SERVICE BULLETIN

APPLICABILITY: 2014MY XV Crosstrek Hybrid (HEV)
SUBJECT: Revised Rear Combination Lamp to Prevent Condensation

NUMBER: 07-81-14
DATE: 02/03/14

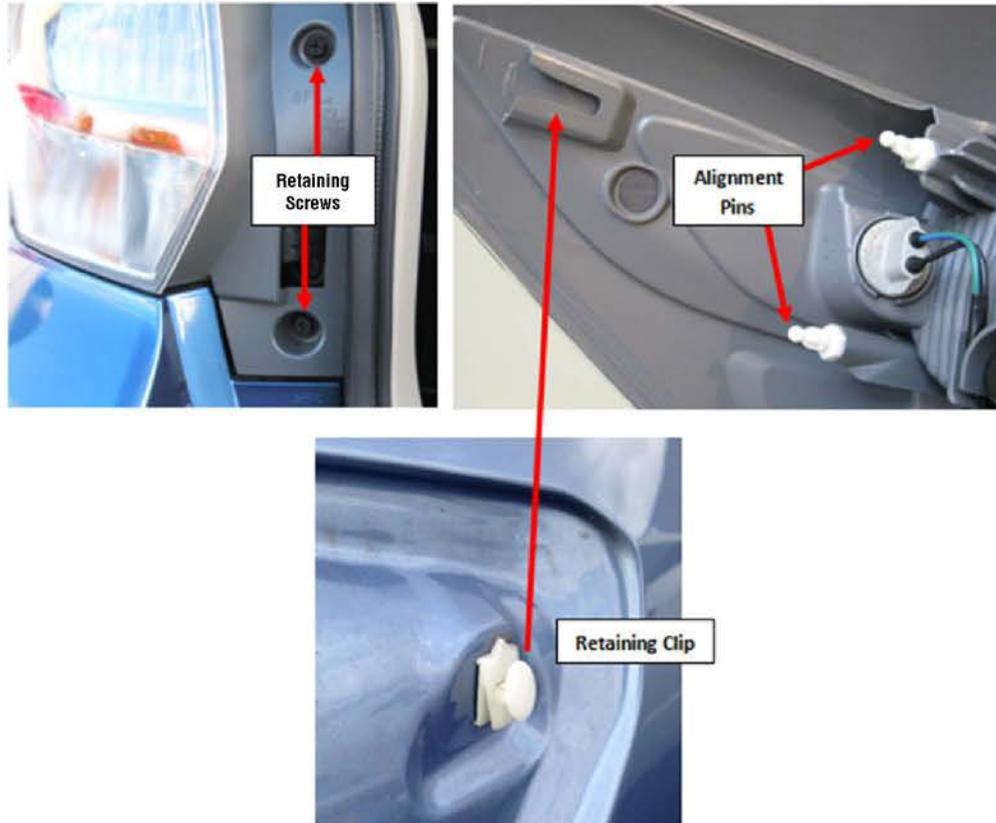
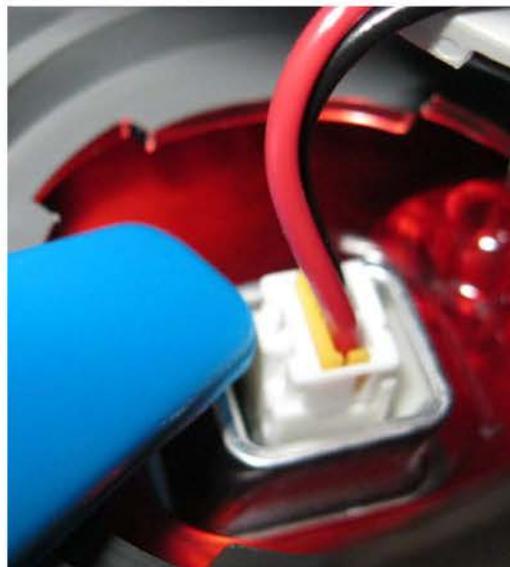
A revised rear combination lamp assembly has been developed which utilizes additional sealing material in four areas designed to prevent condensation from occurring on the inside of the housing. When performing this procedure, replace BOTH rear combination lamps at the same time.

- Remove the two 10mm retaining screws then wiggle / slide the lamp assembly **straight back** toward the rear of the vehicle to release it from the body side retaining clip and alignment pins as shown in the photos below.

- Disconnect the lamp harness to body harness connector.
- Once the combination lamp assembly is removed, remove all the bulb sockets from the housing as shown below and unclip the harness connector from the mounting bracket.
- Using a plastic trim tool, **CAREFULLY** release the LED harness connector retaining tab as shown below.

- The wiring harness assembly must be transferred over to the replacement combination lamp.
- **NOTE:** To properly position the harness into its retaining groove in the housing, the new additional sealing material just above the harness connector will need to be partially removed for access as shown in the photo sequence below. Do not disturb the material any more than necessary to properly position the harness.
- **CAREFULLY** lift/ peel the material up then, once the harness is tucked fully into the groove using a plastic trim tool, push the material back down into place.

- Tuck the LED harness past the sealing material into its corresponding retaining groove.

- Reinstall all the bulb sockets, reconnect the vehicle harness then refit the combination lamp making sure the slot in the side of the housing engages the retaining clip on the body properly.
- Start the vehicle and verify all the combination lamp functions operate properly.
- Torque the mounting bolts to 7.5 Nm (5.5 ft-lb) to complete the procedure.
